HYDROLOGY M10/D5 TWO PLANS

RE: CONCEPTUAL DRAINAGE PLAN FOR ALBUQUERQUE SOUTH, UNIT 1
RECEIVED JULY 10, 1987 (M-10/D5)

RE: CONCEPTUAL DRAINAGE PLAN FOR ALBUQUERQUE SOUTH, UNIT 1
RECEIVED MAY 27, 1987 (M-10/D5)

CONCEPTUAL
DRAINAGE REPORT

TEMPORARY DRAINAGE EASEMENT

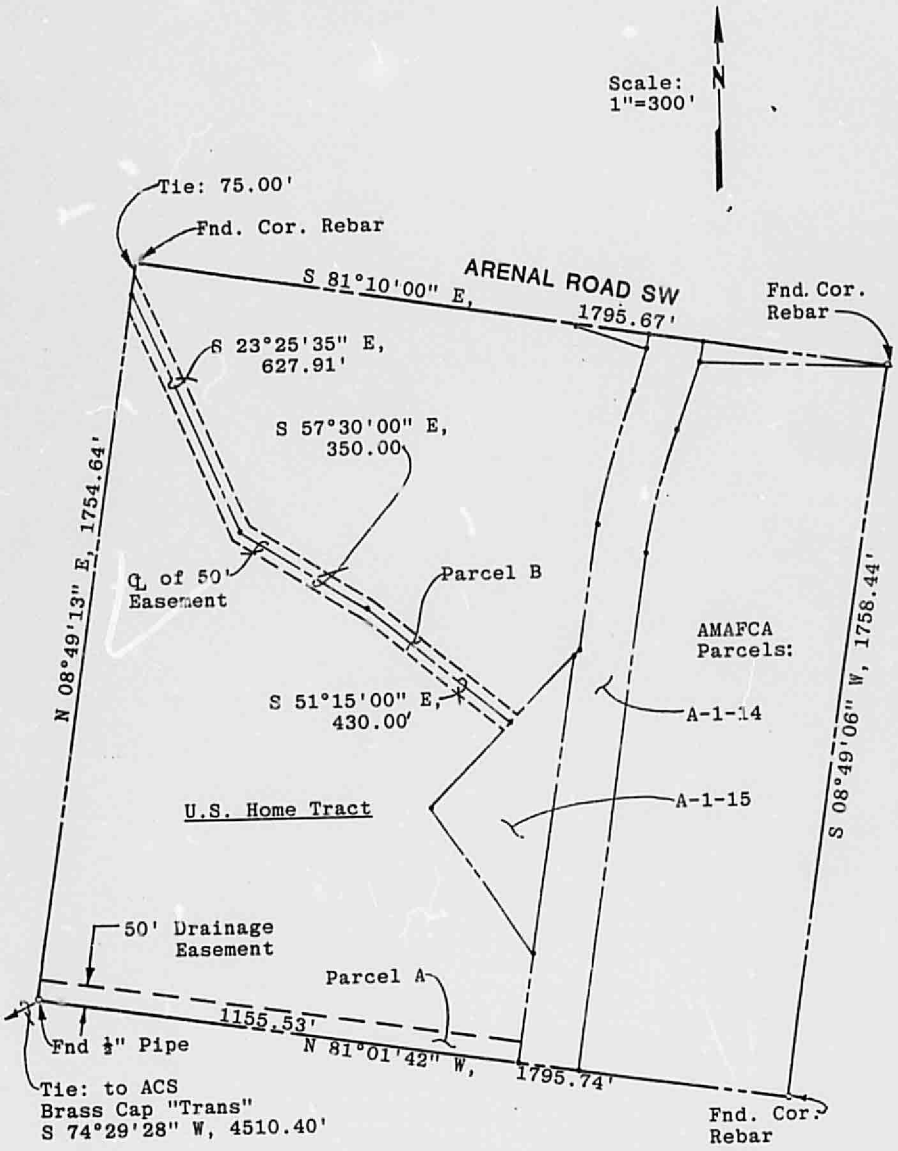
In response to another concern not listed in your letter, but expressed in our conversation, we are enclosing a copy of the filed offsite drainage easement for the adjacent downstream tract.

TEMPORARY DITCH / DIKE
No Scale

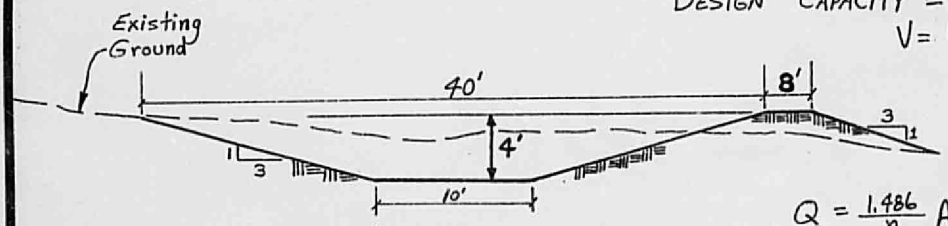
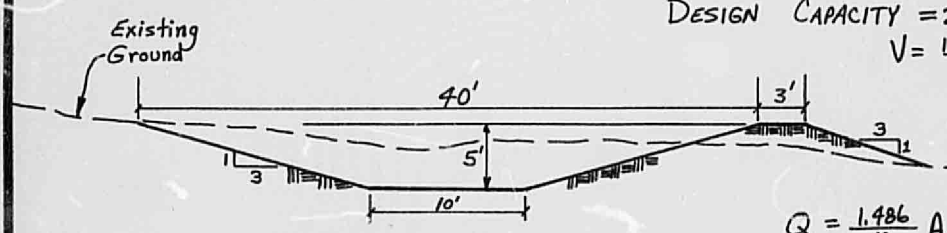
2. Please refer to Section 22.3 (Berms and Levees) in the DPM for criteria concerning the east berm.

4. AP #1 equals 175 cfs and AP #2 equals 174 cfs. However, the ditch/dike section on sheet 23 is a design for only 200 cfs.

2. A revised ditch/dike section is included which is in conformance with the requirements in Section 22.3 of the DPM.

4. The discrepancy you noted is due to the fact that two different runoff calculation methods were used per DPM criteria. The drainage areas discharging at analysis point 1 and analysis point 2 were both evaluated using the Rational Method, while the SCS Method was used for the entire combined area of approximately 485 acres. The total runoff figure then does not correspond to a direct summing of the two sub-areas.

SUBJECT Ditch/Dike Section JOB NO. 323
BY SMM DATE 5.8.87 SHEET NO. ___ OF ___
REVISED 7.9.87 SMM

If ditch depth equals 4.0', then freeboard provided will be 4.0 − 2.1 = 1.9 ft. (2' OK)

If ditch depth equals 5.0', then freeboard provided will be 5.0 − 2.1 = 2.9 ft. (OK)
